# WEBSTER UNIVERSITY ISB

Z001 COVER / INDEX/ NOTES
Z200 ELEVATION
Z201 ELEVATION
Z300 SECTIONS
Z301 SECTIONS
Z302 SECTIONS
Z303 SECTIONS
Z500 DETAILS
Z501 DETAILS

# SUBMITTAL IDENTIFICATION SHEET

05 4000-001 REV002
CANNON DESIGN SUBMITTAL NUMBER

DRAWING NO.: Z300
SHEET NO.: 4 OF 9

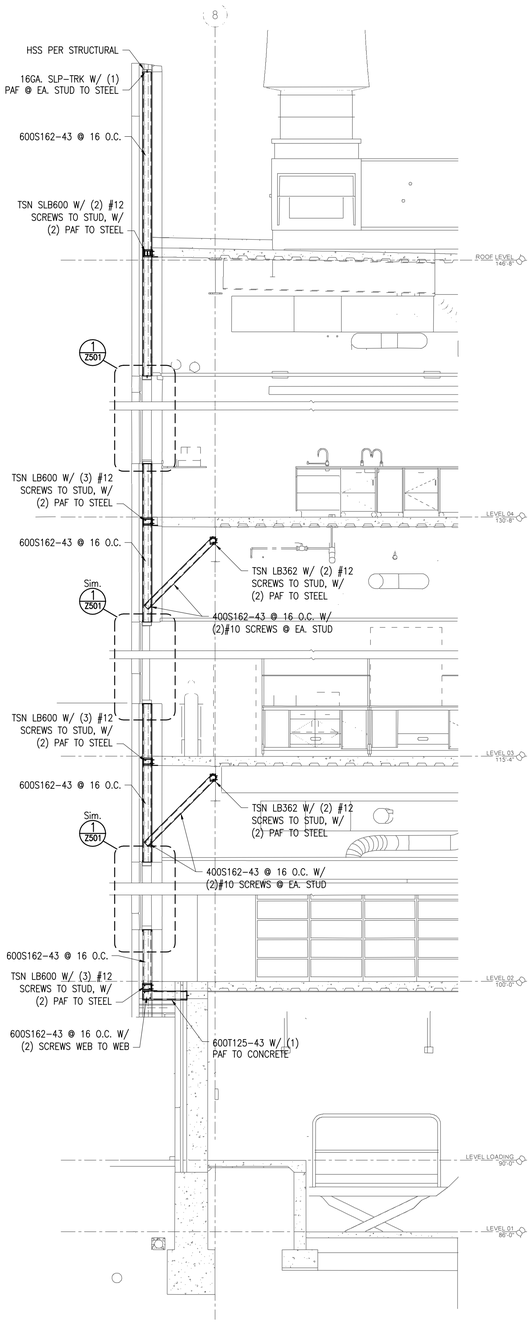
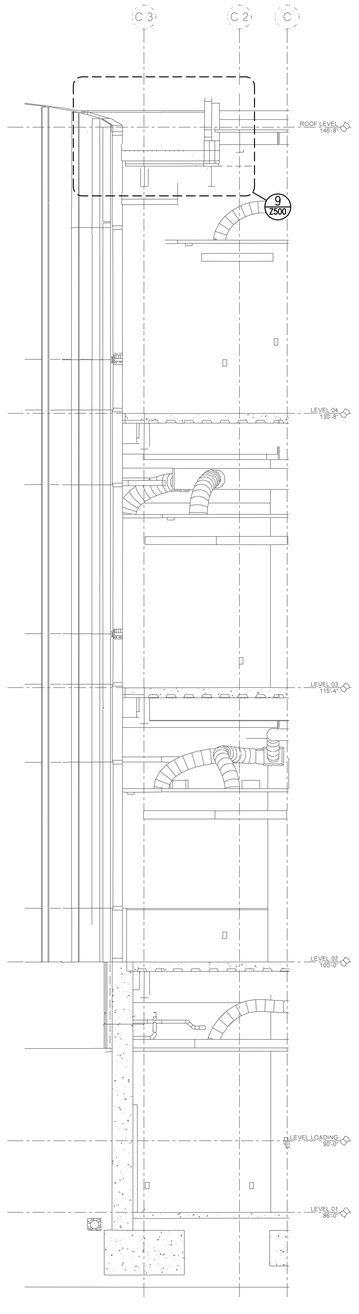
PER THE SPECIFICATIONS SECTION 054000 ALL CFMF EXTERIOR NON-LOAD-BEARING WALL FRAMING SHALL BE AS REQUIRED BY STRUCTURAL PERFORMANCE BUT NOT LESS THAN 16 GAUGE

3 Z300 WEST WALL SECTION A– ISB OVERHANG
REF. 1/A0406 | 1/4"=1'-0"

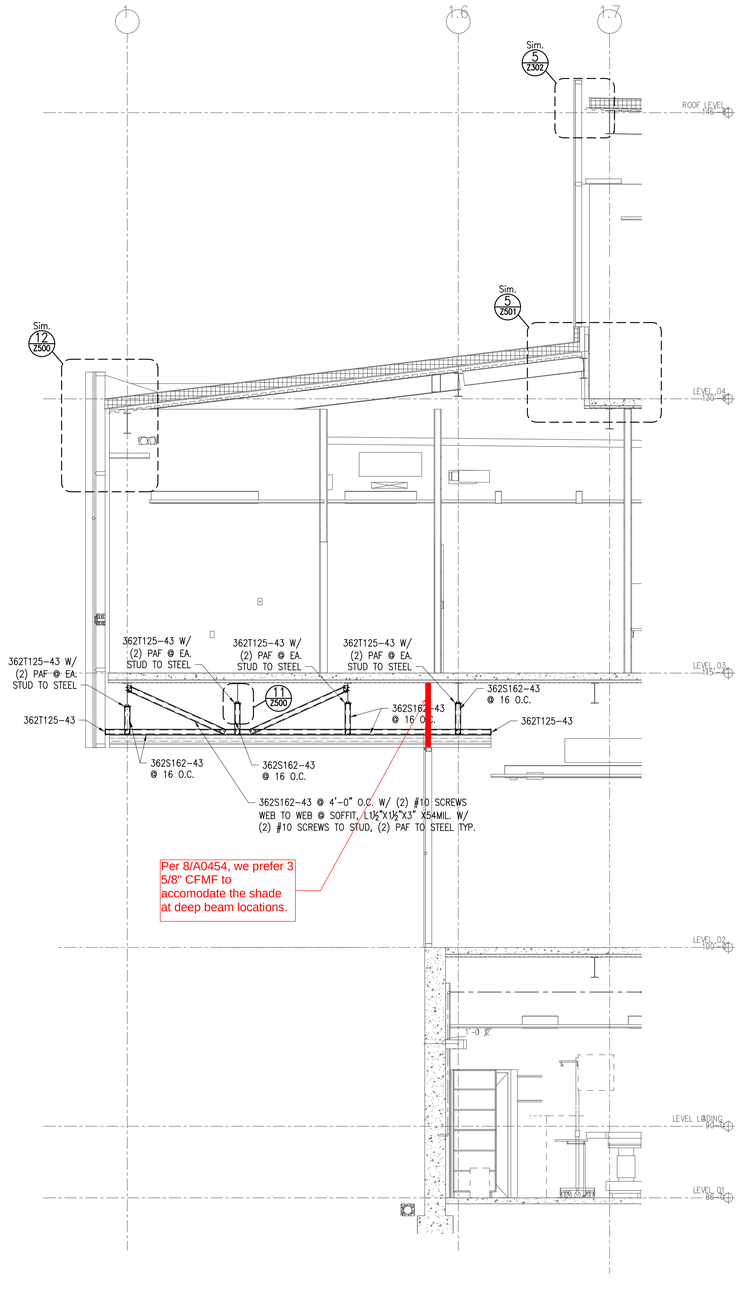
Coordinate and adjust framing to accommodate continuous shade pockets at glazing adjacent to cantilever soffit on west side.

FOR COMMENTS 3/Z300 AND 2/Z303: REFERENCE FROM 074243-003 MARKUP FOR SHADE POCKET

DRAWING NO.: Z301
SHEET NO.: 5 OF 9

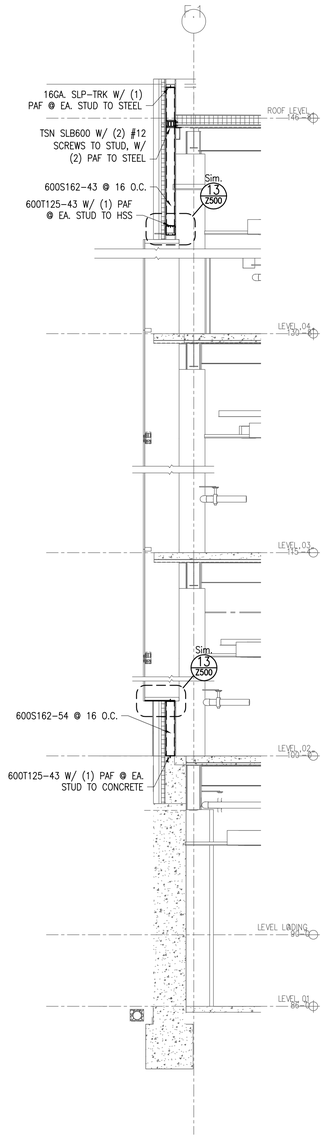
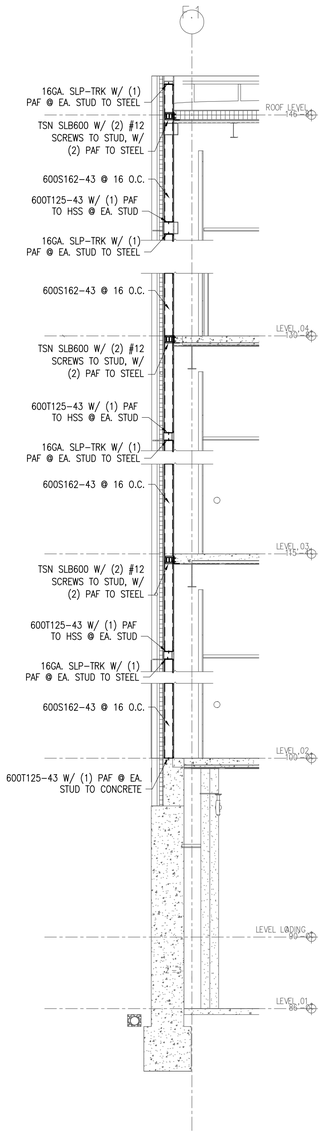
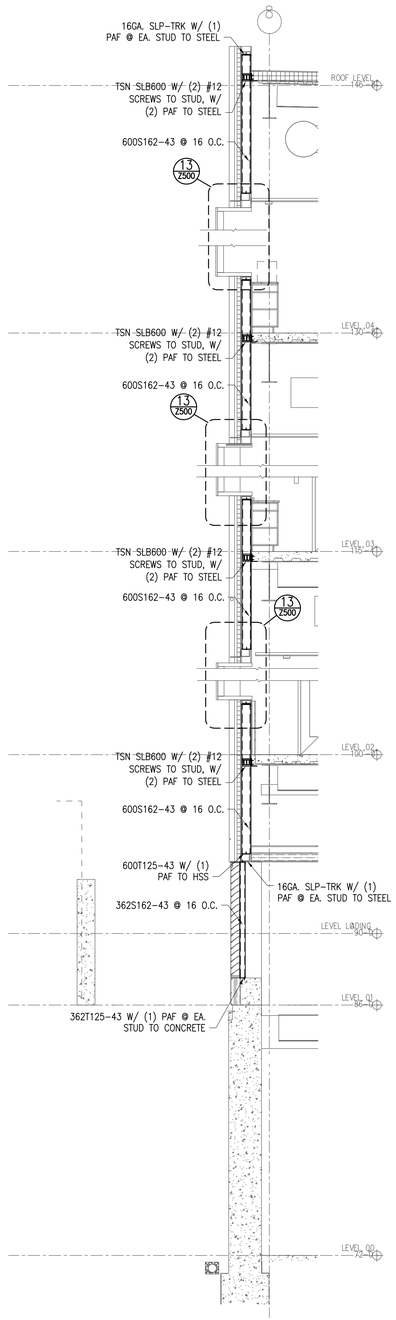
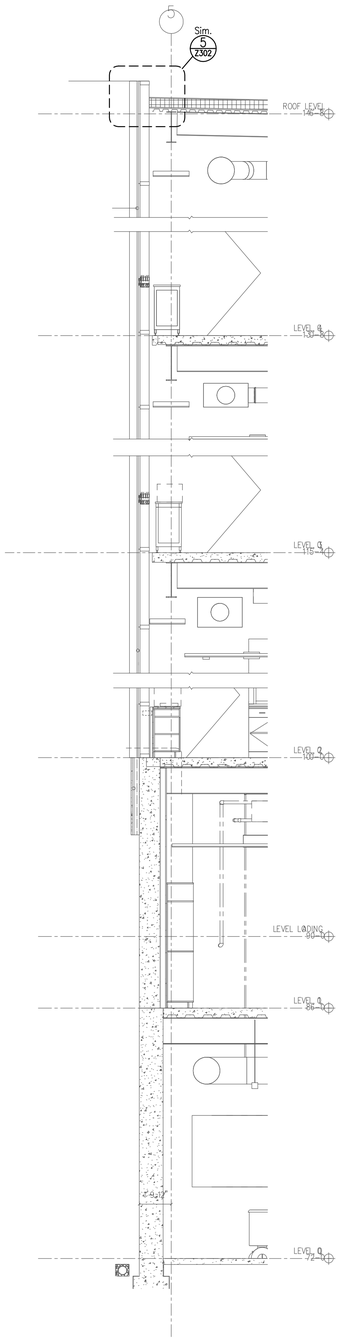
PER THE SPECIFICATIONS SECTION 054000 ALL CFMF EXTERIOR NON-LOAD-BEARING WALL FRAMING SHALL BE AS REQUIRED BY STRUCTURAL PERFORMANCE BUT NOT LESS THAN 16 GAUGE

DRAWING NO.: Z302
SHEET NO.: 6 OF 9

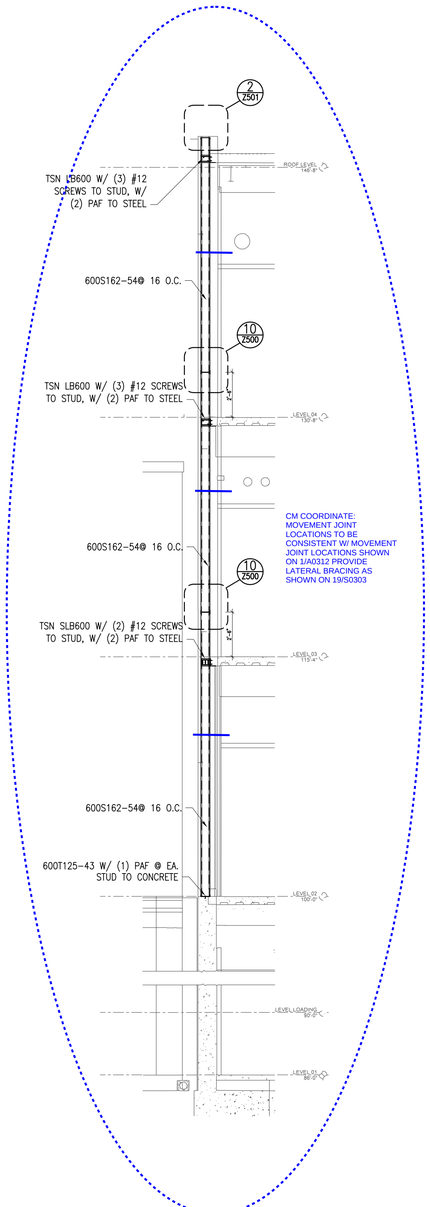
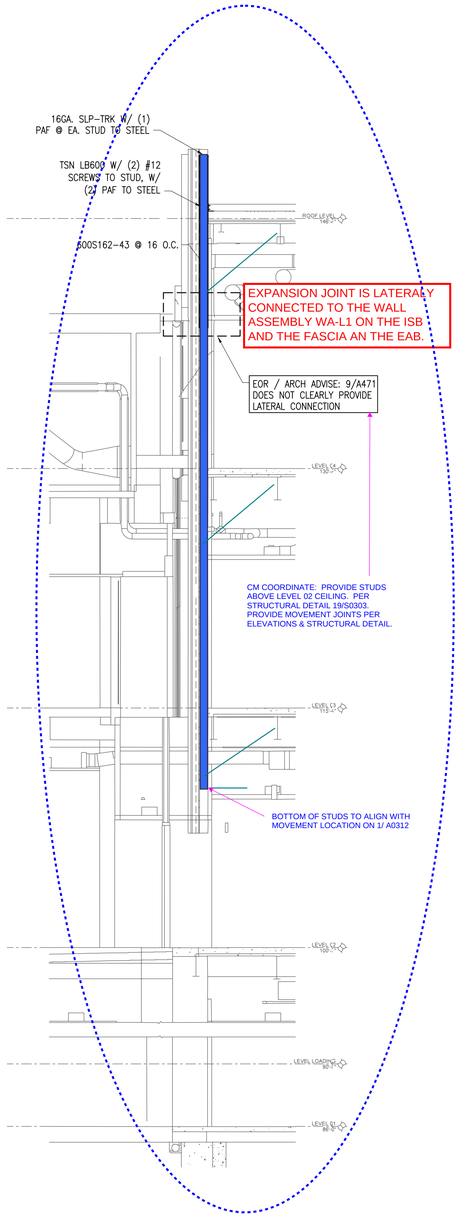
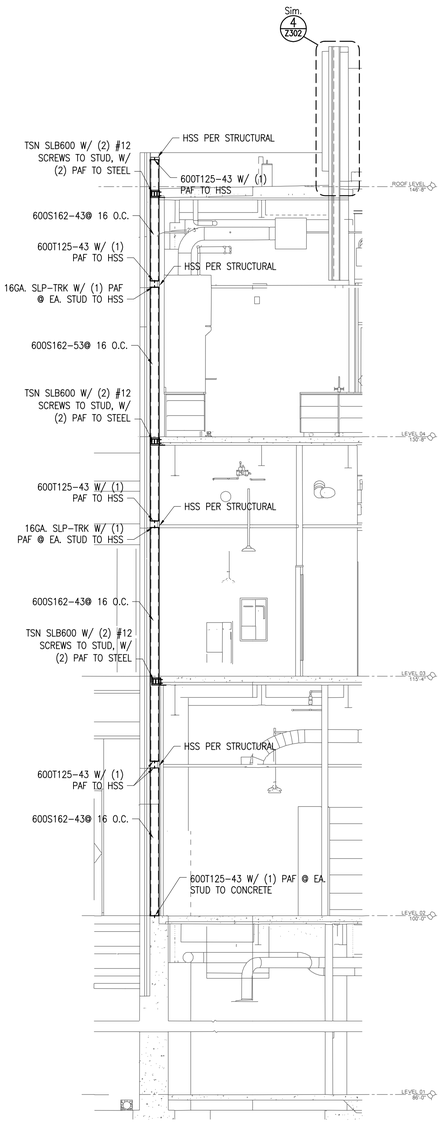
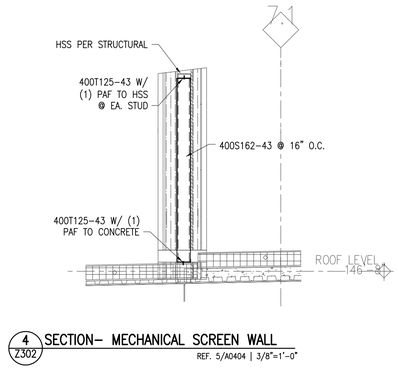
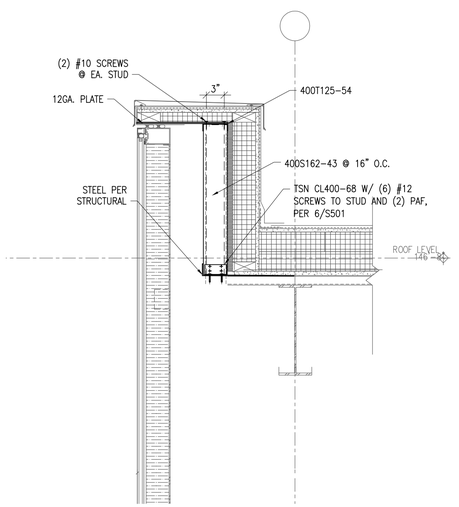
PER THE SPECIFICATIONS SECTION 054000 ALL CFMF EXTERIOR NON-LOAD-BEARING WALL FRAMING SHALL BE AS REQUIRED BY STRUCTURAL PERFORMANCE BUT NOT LESS THAN 16 GAUGE

DRAWING NO.: Z303
SHEET NO.: 7 OF 9

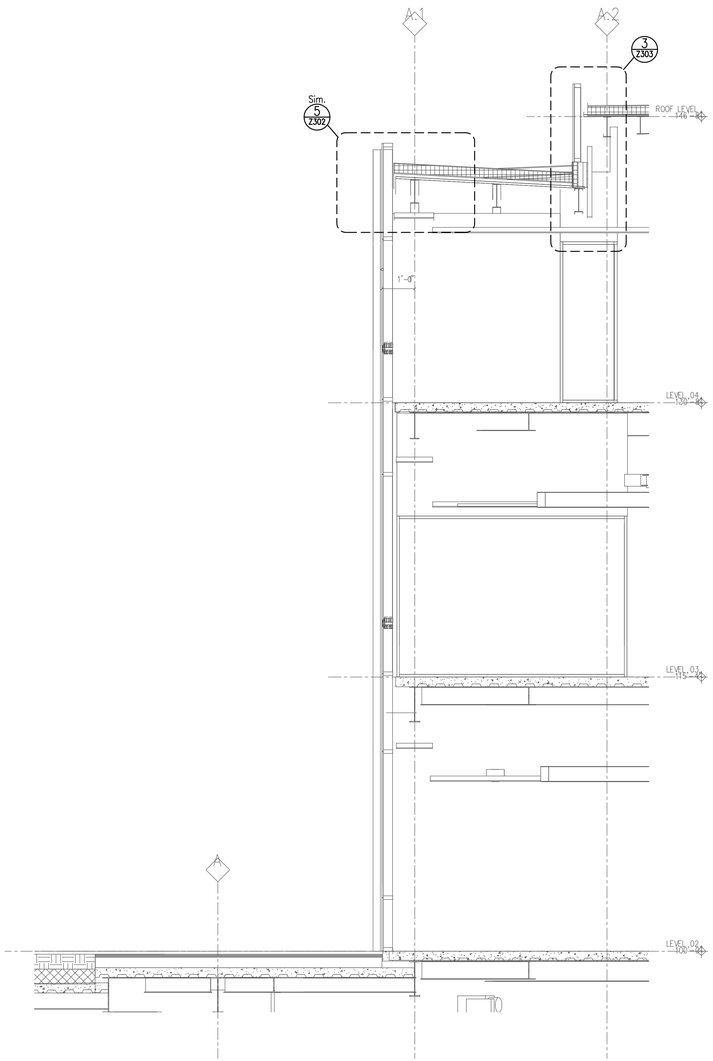
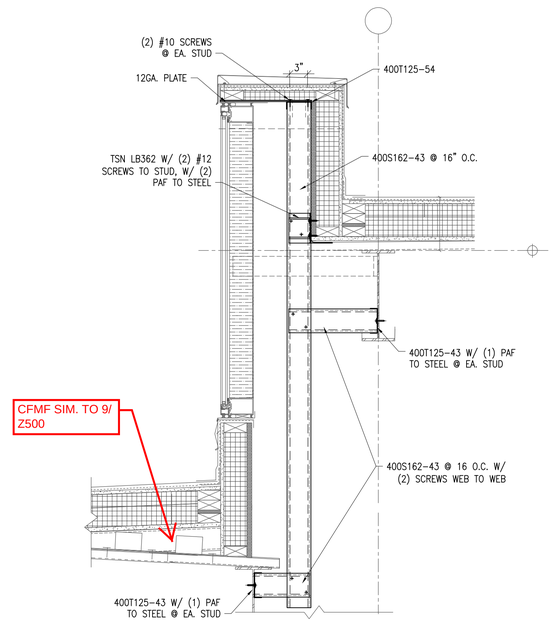
PER THE SPECIFICATIONS SECTION 054000 ALL CFMF EXTERIOR NON-LOAD-BEARING WALL FRAMING SHALL BE AS REQUIRED BY STRUCTURAL PERFORMANCE BUT NOT LESS THAN 16 GAUGE
